BOARD OF ZONING APPEALS DIVISION I

Case Number: 2026-DV1-023
Property Address: 4000 Michigan Road (approximate address)
Location: Washington Township, Council District #7
Petitioner: Art Association of Indianapolis Indiana, by Brent Bennett
Current Zoning: SU-7

Request: Variance of Development Standards of the Consolidated Zoning and Subdivision Ordinance to provide for the location of two monument signs along the 38th Street frontage and one monument sign along the Michigan Road frontage, being the second and third primary freestanding signs along 38th Street (maximum two signs permitted) with heights of 9 feet and 12 feet (maximum 5 feet permitted) and with a separation of 75 feet between the 38th Street signs (300-foot separation required), and a canopy sign with a projection from the wall exceeding 18 inches (maximum 18 inches permitted).

2026DV1023 ; Elevations (S1 – Canopy Sign)

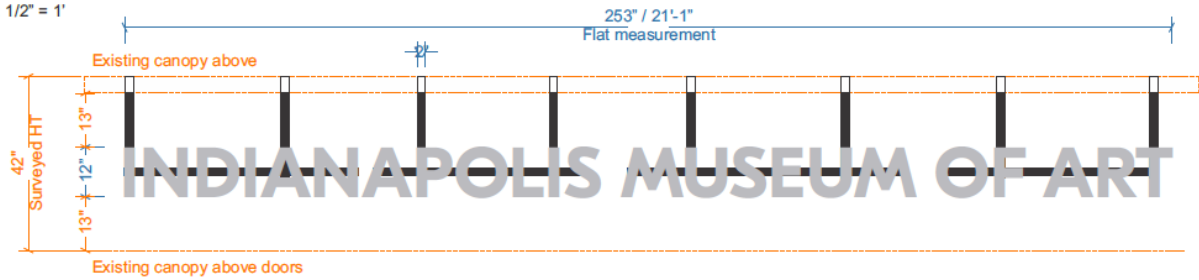
- **S1:** The canopy sign proposed (a type of primary building sign) would have a separation of more than 18 inches from the wall of the primary building itself. A maximum projection of 18 inches for canopy signs would be allowed.
- **S2:** These two monument signs would be the second and third overall primary freestanding signs along the 38th Street frontage (the 'Newfields' sign at the corner of 38th and Michigan would be the first), and a maximum of two primary freestanding signs per shared frontage would be allowed. A distance of 300 feet is required between primary freestanding signs on the same frontage, and the two new S2 signs would be approximately 75 feet apart. Additionally, the sign heights of 9 feet would exceed the maximum 5-foot height for the district.
- **S3:** Placement of this monument sign would result in a sign height of 12 feet (5-foot maximum).

The design and placement of the proposed canopy sign would not allow for it to be classified as a wall sign per the Ordinance, since the sign itself would be suspended from an architectural feature as opposed to being attached to the building façade. This is a somewhat unique situation, and the current building form would not allow for placement of a canopy sign that would meet the Ordinance standard of being placed within 18 inches of the wall while also still being visible for patrons of the museum. Staff feels that the proposed canopy sign would serve a similar function to a wall sign or other primary building sign, and the canopy sign comfortably meets other standards for sign size, width, etc. Staff therefore recommends **approval** of the requested variance for the canopy sign affixed to the primary building.

2026DV1023 ; Elevations (S2 – 38th Frontage)

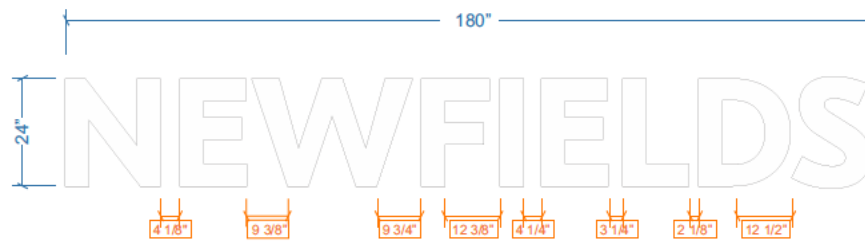
Findings of Fact provided by the applicant indicate that the proposed S2 and S3 signs would be of a similar scale and intensity to signs already existing along the busy 38th Street and Michigan Road frontages. Staff would note that the existing sign at the corner of 38th and Michigan would have substantial separation from the newly proposed signs, to the extent that the existing sign would not be visible from either of the newly proposed locations. Staff also feels that utilizing existing decorative walls for placement of the monument signs would be preferable to establishment of new primary freestanding signs, even if deviating from the maximum height of 5 feet. For these reasons, staff recommends **approval** of the variances related to sign separation, number and height for the proposed S2 and S3 signs.

Photo 3: Western S2 Location Viewed from South

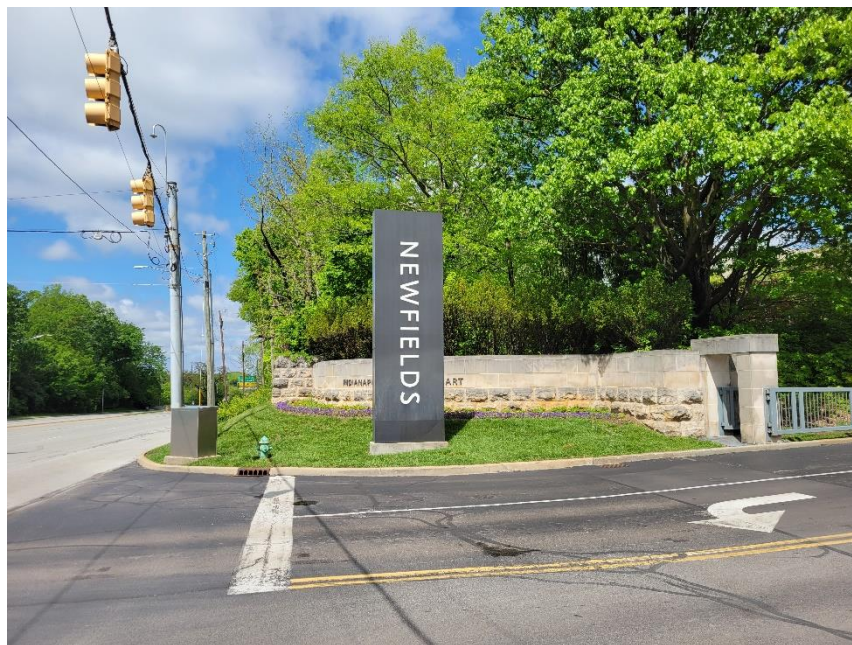
The existing pylon sign along 38th Street near the proposed S2 signs would be removed as a part of this scope of work, and would therefore not impact the proximity calculation above.
